USCG  
Bridge Division  
I-5 IBR bridge proposal comments  
U.S. Coast Guard Public Notice PN-04-25 - Proposed replacement of the I-5 Portland to Vancouver Bridge, across the Columbia River, river mile 106.5, between Portland, OR. and Vancouver, WA.

### Two Alternatives Not Considered by the IBR offering Significant Benefit

### ***Bridge Alternative Elevation***

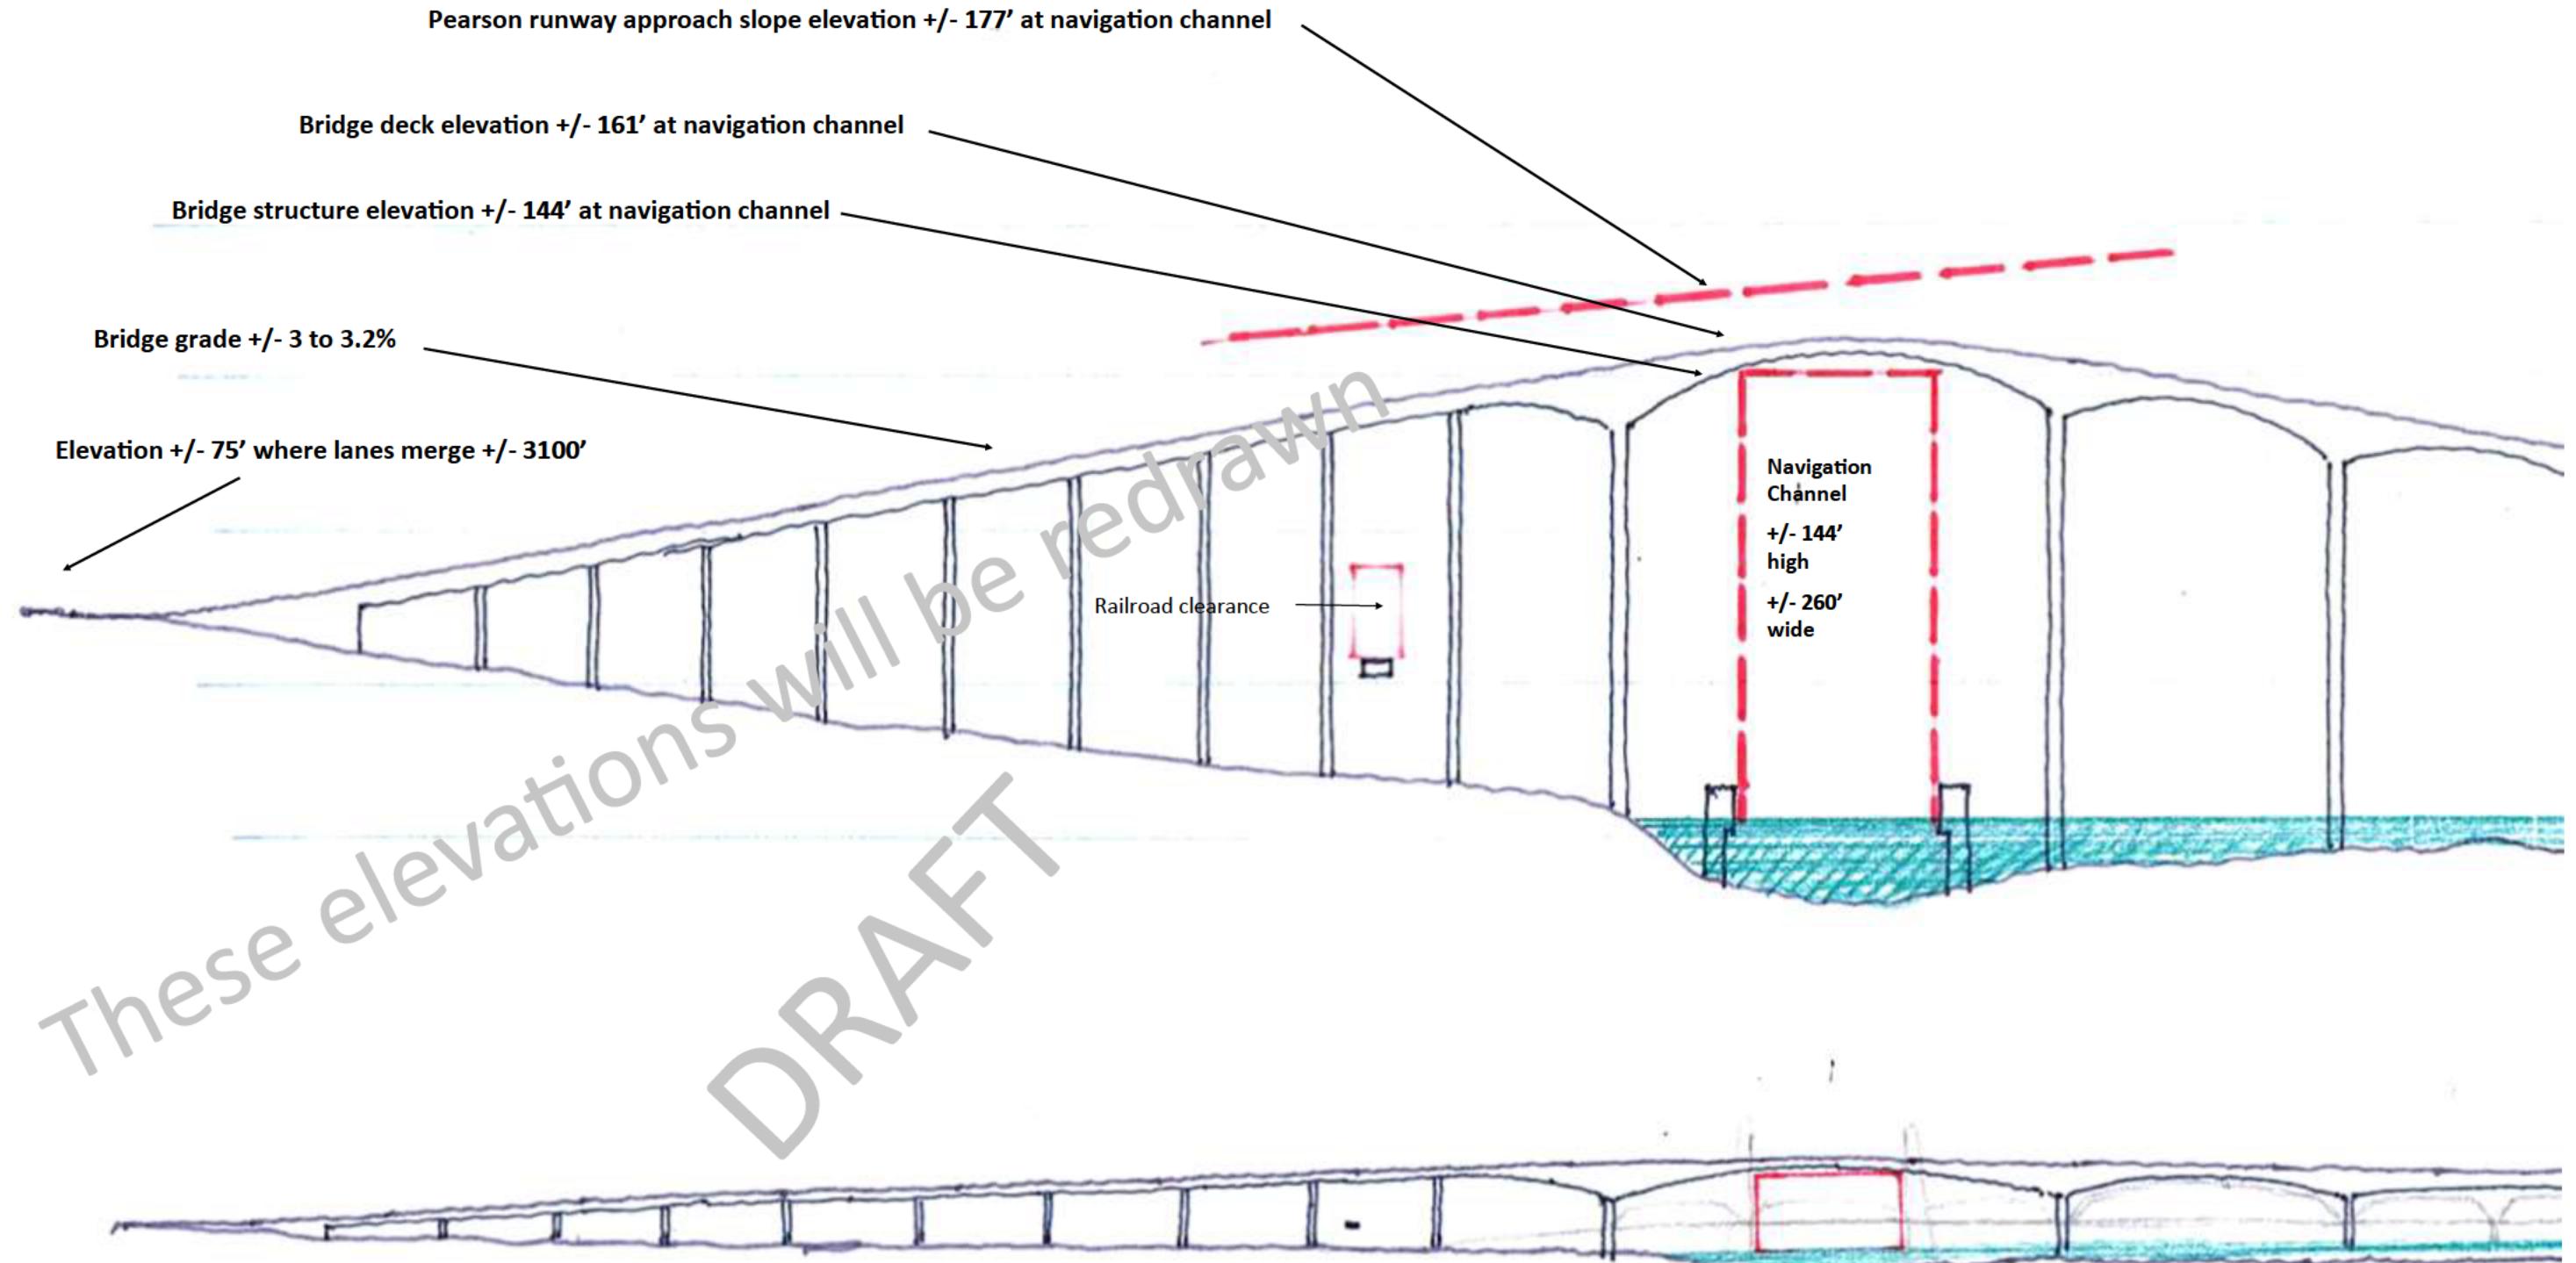
Description of structure elements. These are indicative and generally representative of bridge type structures employed for high level freeway bridges and long river spans. River columns are placed to correspond with every other in-water I-5 piers for navigation channels, river flow, and scour.

Indicative north approach structure consists of multiple 230' to 250' span precast or cast-in-place concrete structures.

Main spans over the river shown are indicative of segmental concrete hunched box girders. The main span at the navigation channel is approximately 800' to 840'. The first span south of the navigation channel is +/- 520' to 540'. See indicative

## Bridge Alternative Elevation

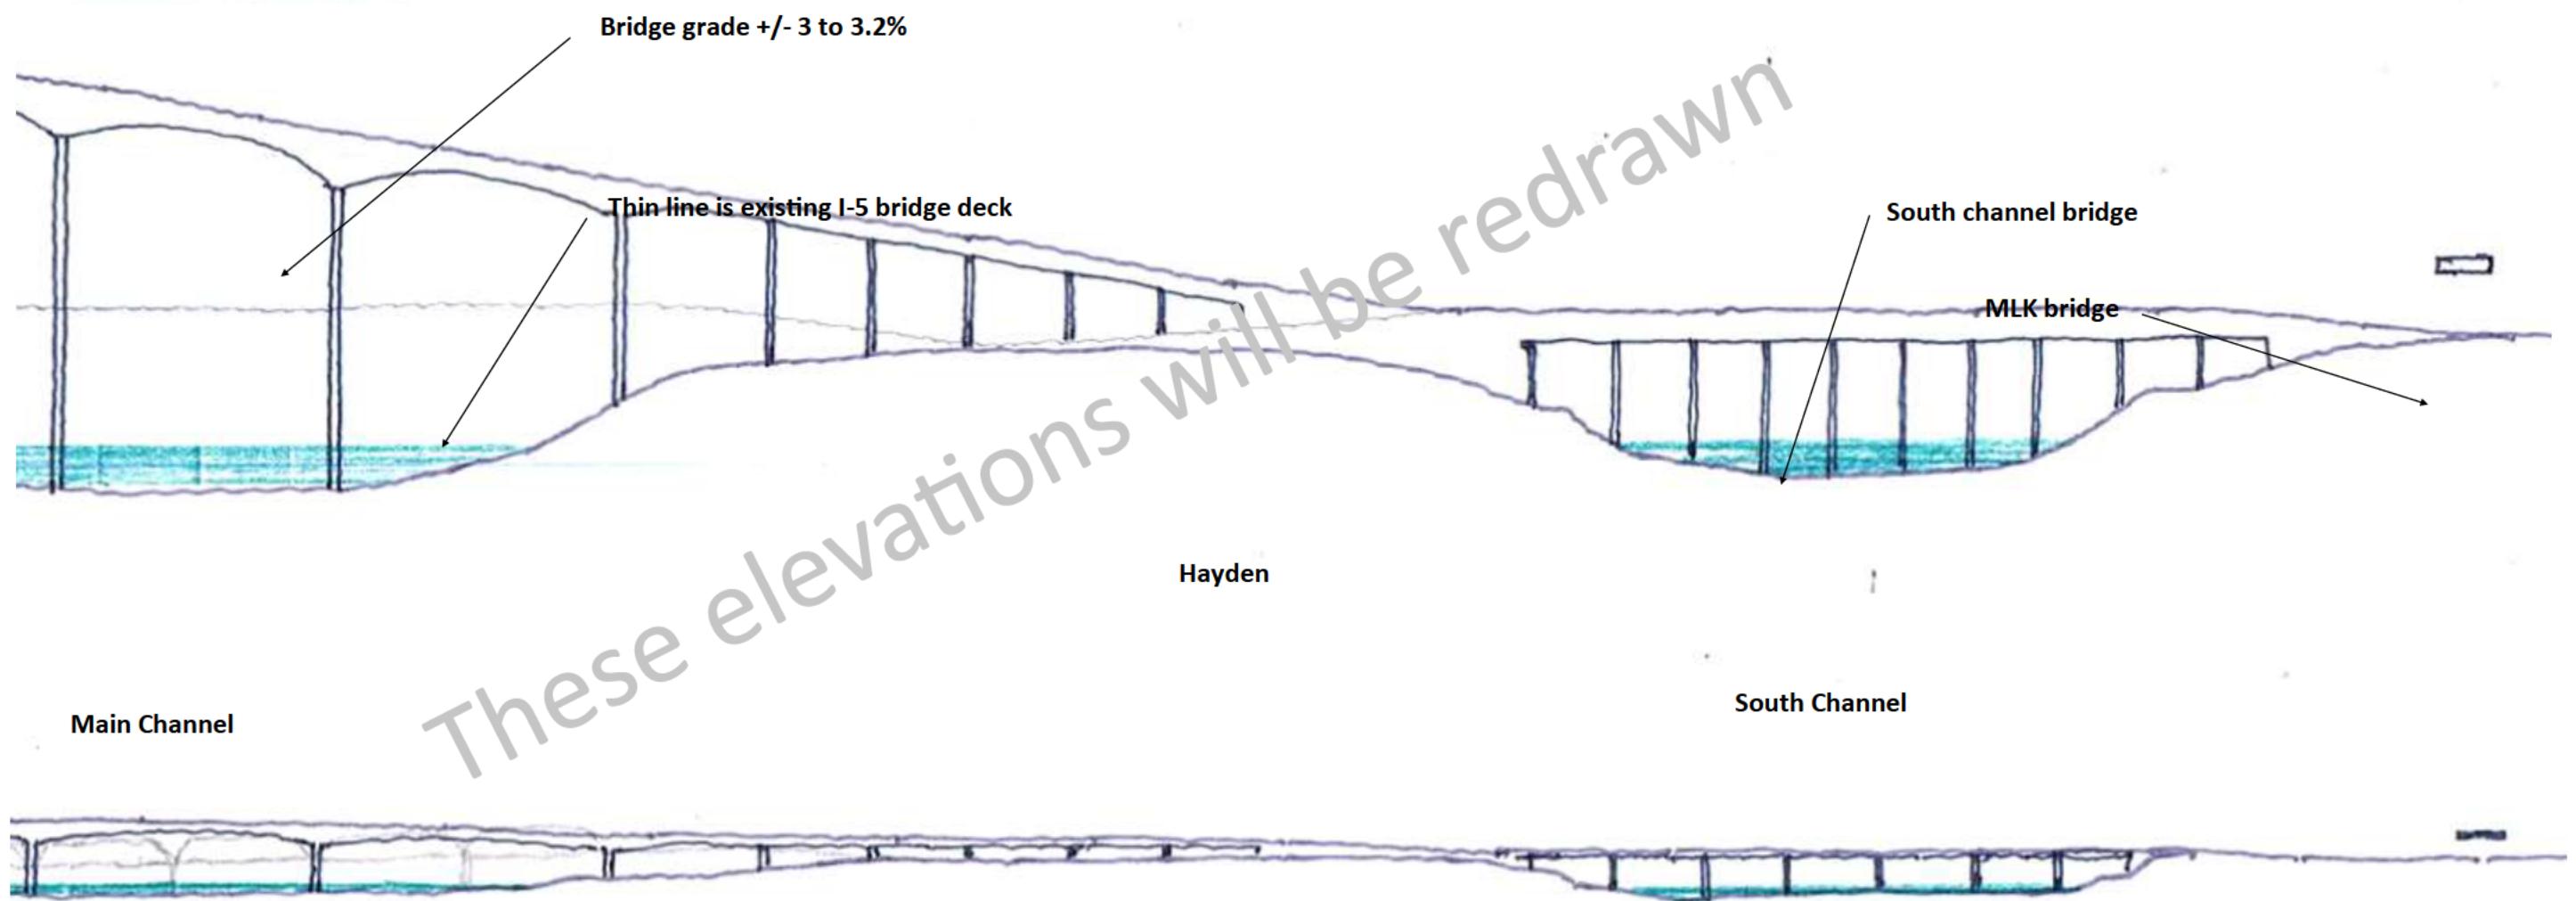
Description of structure elements. These are indicative and generally representative of bridge type structures employed for high level freeway bridges and long river spans. River columns are placed to correspond with every other in-water I-5 piers for navigation channels, river flow, and scour.

Main spans over the river shown are indicative of segmental concrete hunched box girders. Between the +/- 530' span and Hayden Island (3) nominal 350' spans are shown.

Indicative south approach structure consists of multiple 230' to 250' span precast or cast-in-place concrete structures.

South channel bridge widening likely consists of precast concrete girders with spans equal to the existing bridge.

## Pears Airport Runway Background Information

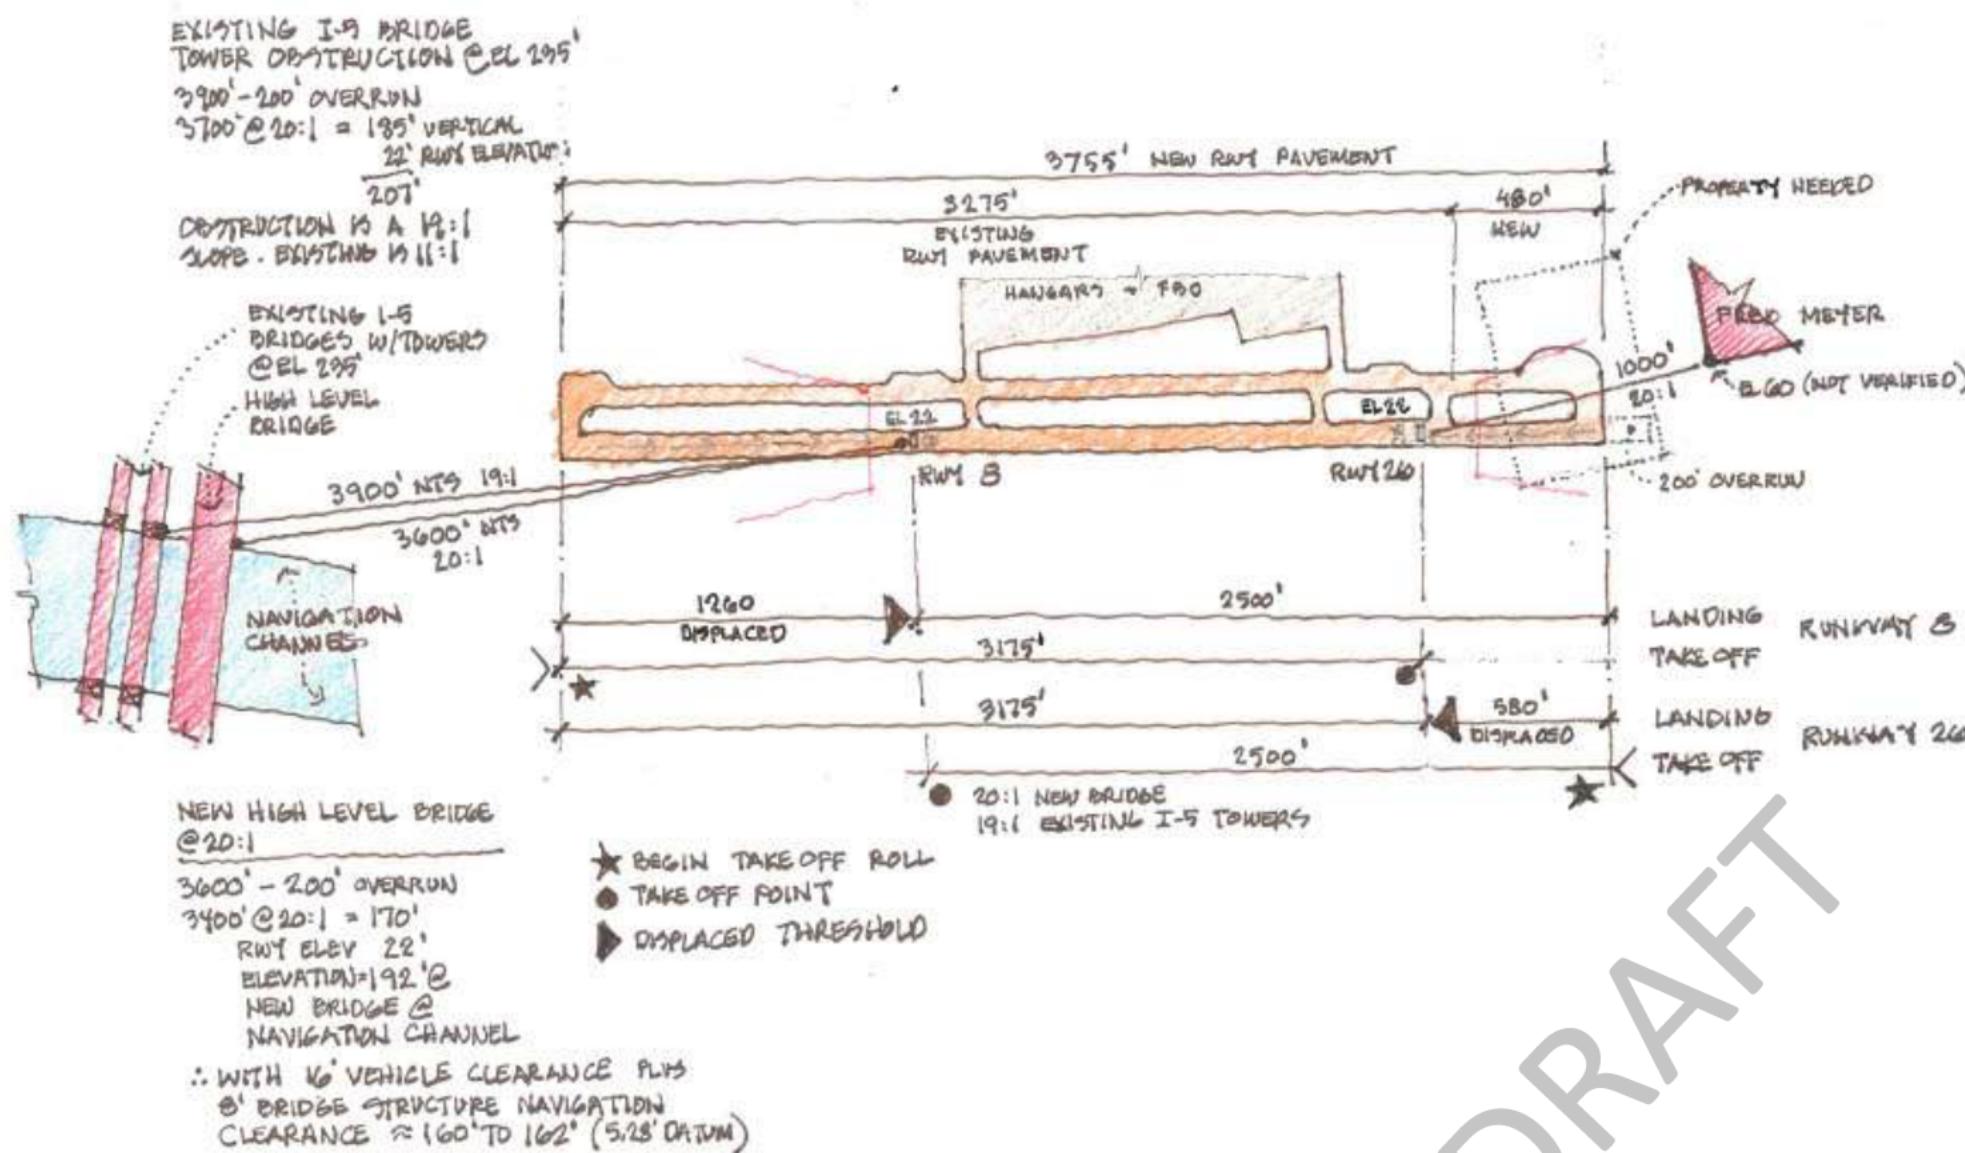
200' beyond the runway threshold a 20:1 'glide slope' is required. This glide slope extends beyond the I-5 corridor. Curiously, the existing displaced threshold results in an 11:1 glide slope with the towers of the existing I-5 lift structure. This is most curious in that the airport authority shifted the runway west to accommodate the blue roofed building.

Pearson Airport. Note the runway is 2,500' long with a nominal 770' displaced threshold on the east (runway 28). This displaced threshold was done to allow the building with the blue roof.

The roof of the Fred Meyer building governs where the runway threshold can be shifted to the east. Shifting the runway to the east allows greater clearance at the navigation channel.
